| TITLE | AX2000 EXHAUSTSUPPORT BOLT, AX2000 TRIM TAB HORN, STEERING LINKS. |
| CLASSIFICATION | PEGASUS AVIATION CONSIDER THIS BULLETIN TO BE COMPULSORY. |
| APPLICABILITY | AX2000 |

Figure 1.

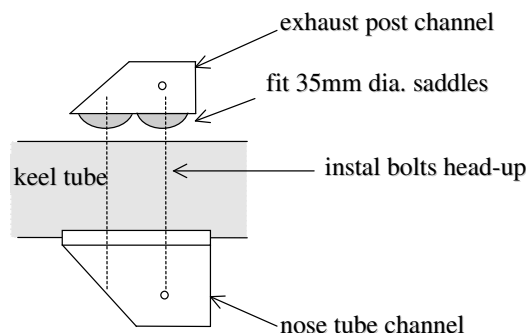
The vertical bolt connecting the silencer support channel to the keel has broken on two AX2000 aircraft. The bolt is installed upside down in the original design. The saddle under the exhaust mounting channel is also of small diameter. Sideways vibration of the exhaust therefore causes leverage on the bolt threads, so the bolt fails in fatigue.

The consequences of a failed vertical bolt are that the exhaust post could possibly slide off the top of the keel, enabling the hot exhaust to contact the dacron centre section cover and possibly the battery.

Minor modification AX186 has been introduced to turn the bolt to the head-up orientation and to specify a larger diameter plastic saddle under a larger exhaust mount channel. These measures are to improve the fatigue strength, reduce the loads in the bolt and make failure at the threaded end less critical.

Remove the exhaust post from the channel and the transverse bolt from the nosewheel tube. Remove the top two ty-wraps from the windscreen. Ask an assistant to apply a downward load on the tail whilst observing the nosewheel tube. A gap will open up enabling the vertical bolt to be extracted.

The bolt should be replaced, inserted head upwards, using a larger diameter saddle and a larger exhaust channel. Tighten the M6 nyloc nut and washer, taking care not to crush the keel. The assistant should then apply an upward load on the tail, gently until the nosewheel bolt hole lines up. Replace the bolt. Replace the exhaust post and plastic washers. Replace screen ty-wraps.
